# UNITED STATES PATENT AND TRADEMARK OFFICE

APPLICATION NO.	FILING DATE	FIRST NAMED INVENTOR	ATTORNEY DOCKET NO.	CONFIRMATION NO.
10/591,896	09/07/2006	Recep Tarhan	3759	3414
278	7590	01/07/2011		
MICHAEL J. STRIKER 103 EAST NECK ROAD HUNTINGTON, NY 11743			EXAMINER RASHID, MAHBUBUR	
			ART UNIT 3657	PAPER NUMBER
			NOTIFICATION DATE 01/07/2011	DELIVERY MODE ELECTRONIC

<b>Office Action Summary</b>	<b>Application No.</b> 10/591,896	<b>Applicant(s)</b> TARHAN ET AL.	
	<b>Examiner</b> MAHBUBUR RASHID	<b>Art Unit</b> 3657

## DETAILED ACTION

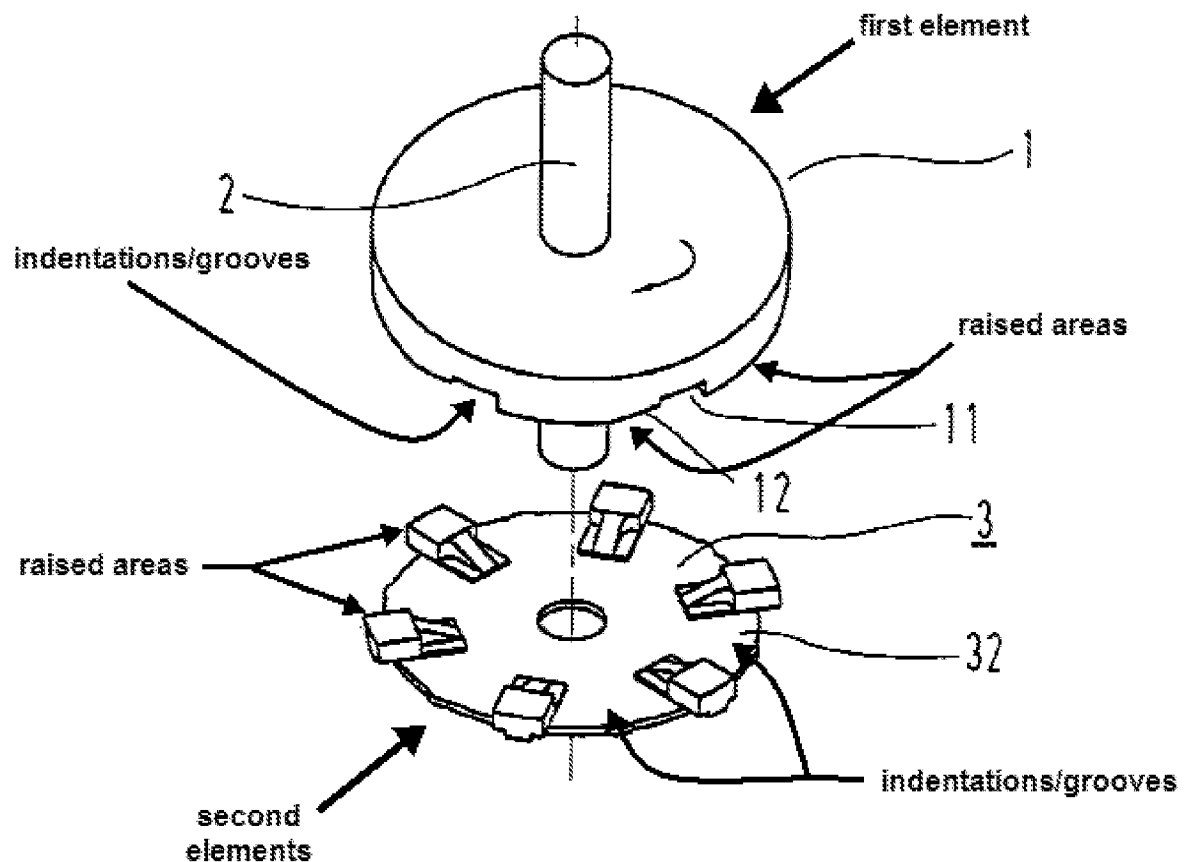
Regarding **claim 1**, Harting discloses a blocking device (figs. 1-3) for (intended of use) blocking a rotary motion of a shaft (2) relative to a housing of a gear-drive unit,

having a first blocking element (1) and a second blocking element (3) which latter is displaceable relative to the first blocking element by means of at least one electromagnet (figs. 1-2; (7)) and at least one restoring element (4), wherein the blocking elements each have radially extending indentations and radially extending raised areas, which mesh with one another in an axial direction in a form-locking fashion to block the rotary motion of the shaft in the blocking state (see figure above and fig. 3 of Harting).

Regarding **claim 22**, Harting discloses a blocking device (figs. 1-3) for (intended of use) blocking a rotary motion of a shaft (2) relative to a housing of a gear-drive unit, having a first blocking element (1) and a second blocking element (3) which latter is displaceable relative to the first blocking element by means of at least one electromagnet (figs. 1-2; (7)) and at least one restoring element (4), wherein the blocking elements each have radially extending indentations and radially extending raised areas, which mesh with one another in an axial direction in a form-locking fashion to block the rotary motion of the shaft in the blocking state (see figure above and fig. 3 of Harting).
